Speed Hump Poll Results - Lonsdale Road

Date: January 14, 2020
To: Toronto and East York Community Council
From: Acting Director, Traffic Management, Transportation Services
Wards: Ward 12, Toronto - St. Paul's

RE: Lonsdale Road, between Spadina Road and Russell Hill Road - Evaluation for installation of traffic calming devices.

1. Drawing No. 421G-3498, dated August 2019
2. Appendix A - Letter from Toronto Fire Services, dated October 8, 2019

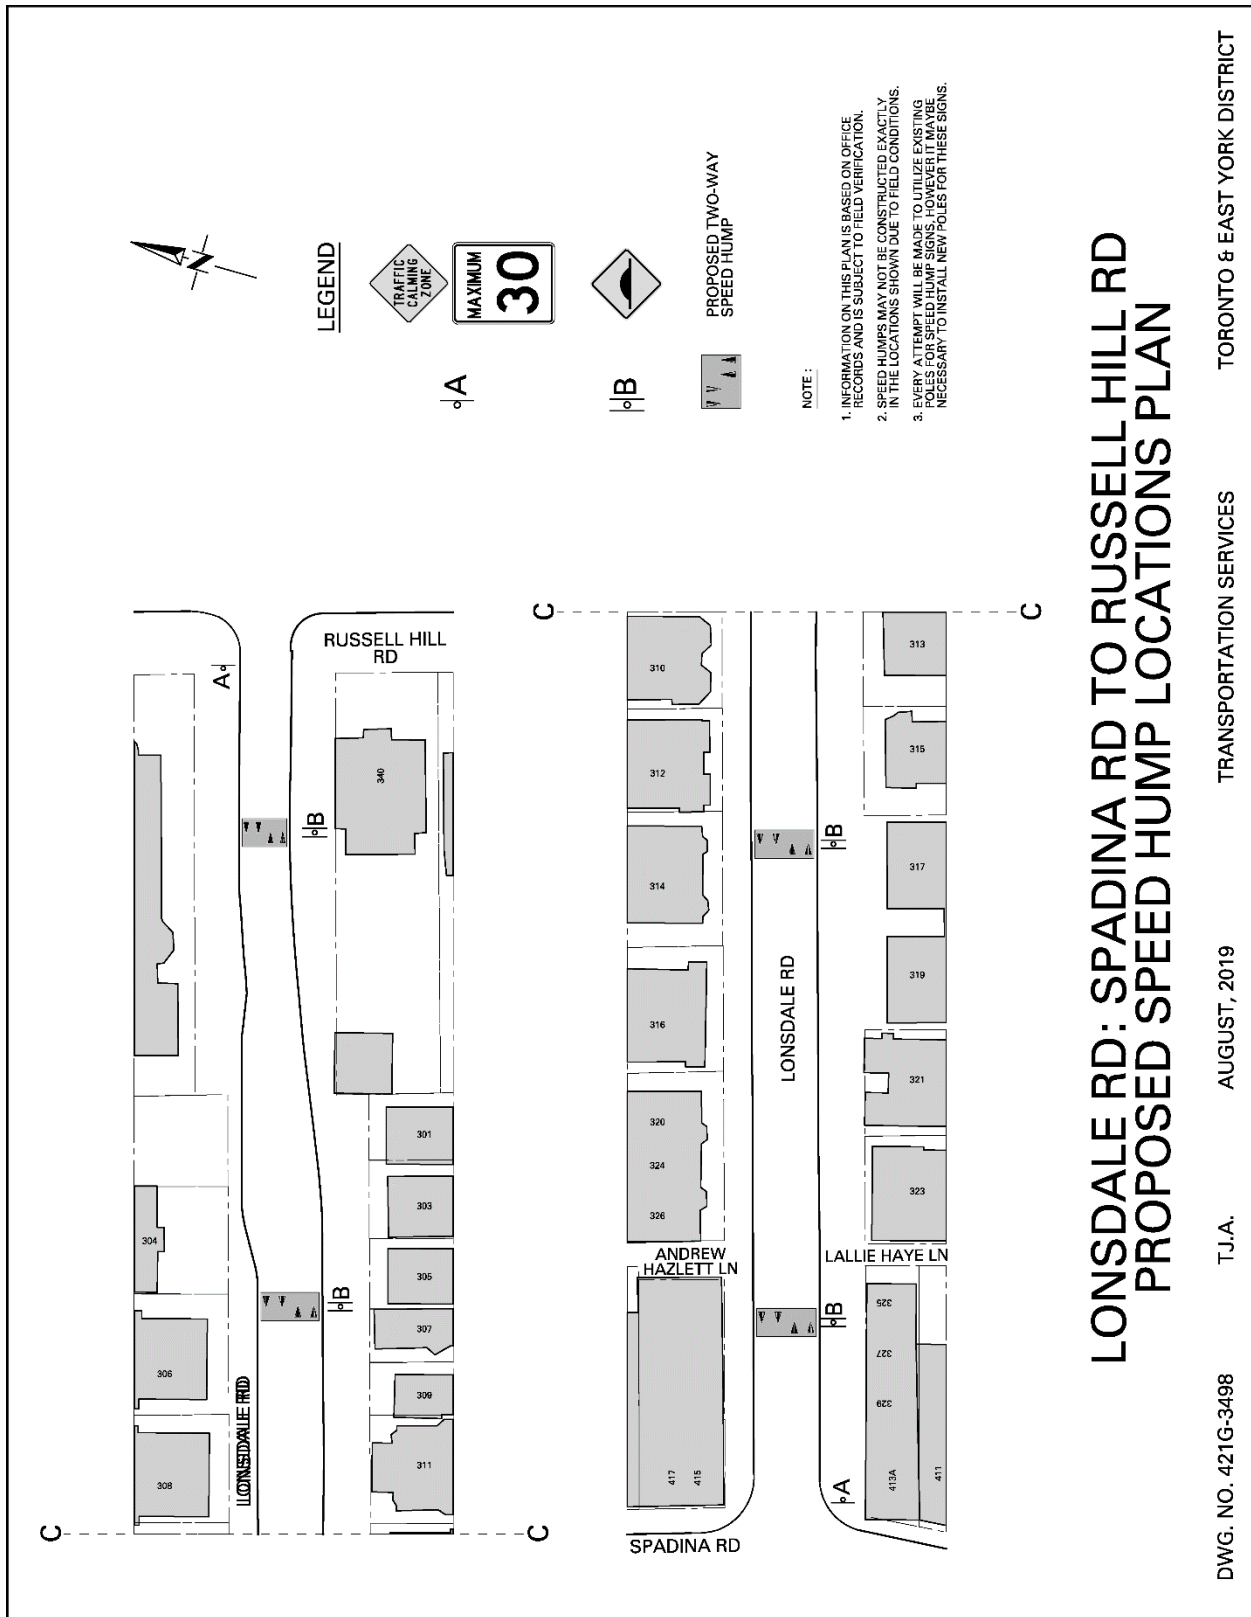
Fire Services does not support the proposed speed hump installation as it may negatively impact our service delivery. The physical restriction imposed by a speed hump have a much greater impact on large fire vehicles. Response time increase with every obstacle encountered on route to any emergency incident and the cumulative impact of several speed hump can be a significant amount of time.

It is important that the all individuals directly affected by this installation be made fully aware of the potential negative effects of the calming device. Careful consideration must be given to accepting a delay to emergency response vehicles as a compromise to combat the risks presented by all vehicular traffic.

Fire Services recommends that non-physical measures (reduce speed limits or prohibited turns) be considered before physical measures are implemented. Desired results may be obtainable without imposing a physical obstruction to emergency vehicles.
